In the Planning and Environment Court  
Held at: Brisbane

No. 137 of 2020

#### AFFIDAVIT

Matthew Currell, Professor at the School of Engineering, RMIT Melbourne, 124 La Trobe St, Melbourne, in the State of Victoria, being under oath, says:

**Figure 2: Daily Rainfall & Recorded Groundwater Levels - 2021**

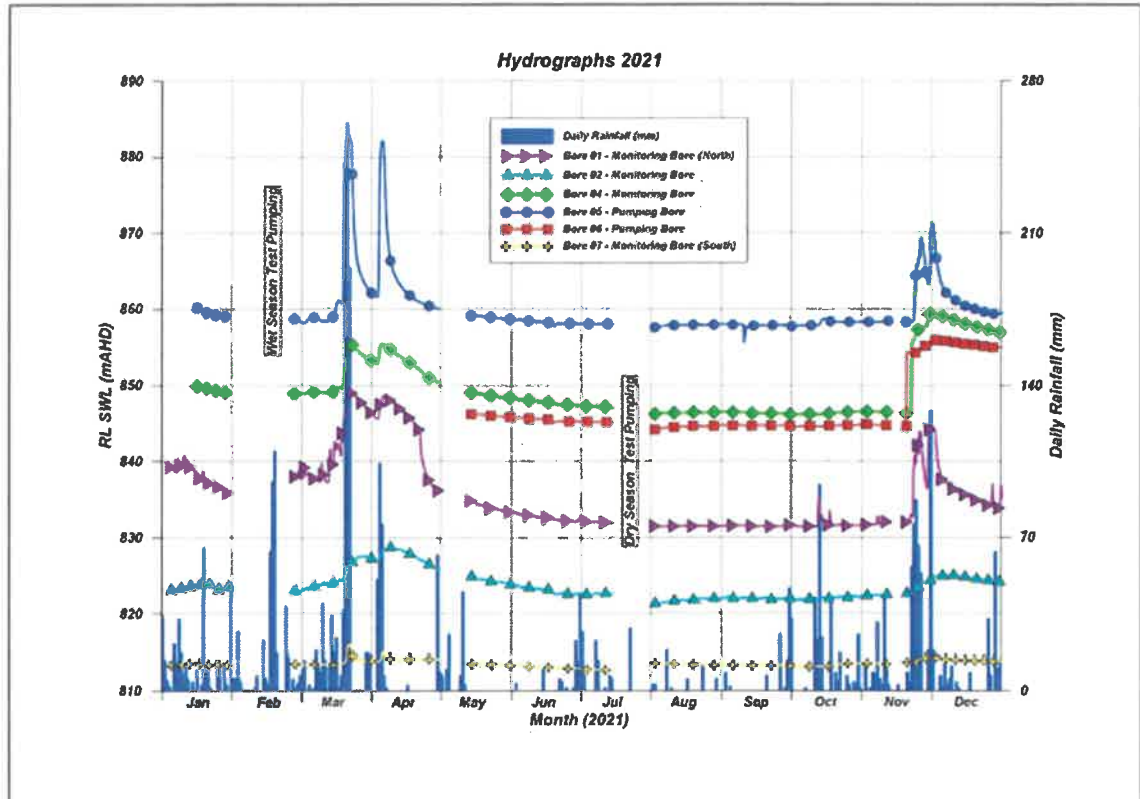
- (h) The groundwater elevations in Bores 1 and 2, which both experienced drawdown during the Dry Season Test, were generally between 820 and 840 m AHD throughout most of 2021 (see Figure 2, p. 3994). This elevation is the critical range within which most of the GDEs at the site (and outside the site to the west of the property) receive flows from the aquifer, as confirmed by evidence of groundwater discharge points during site visits (e.g. in the Affidavit of Elanor Fenge dated 5 November 2021). The Dry Season Test demonstrates that water levels within this critical elevation range are affected by groundwater extraction during dry periods substantially, and this effect is likely to be greater than during wet periods.
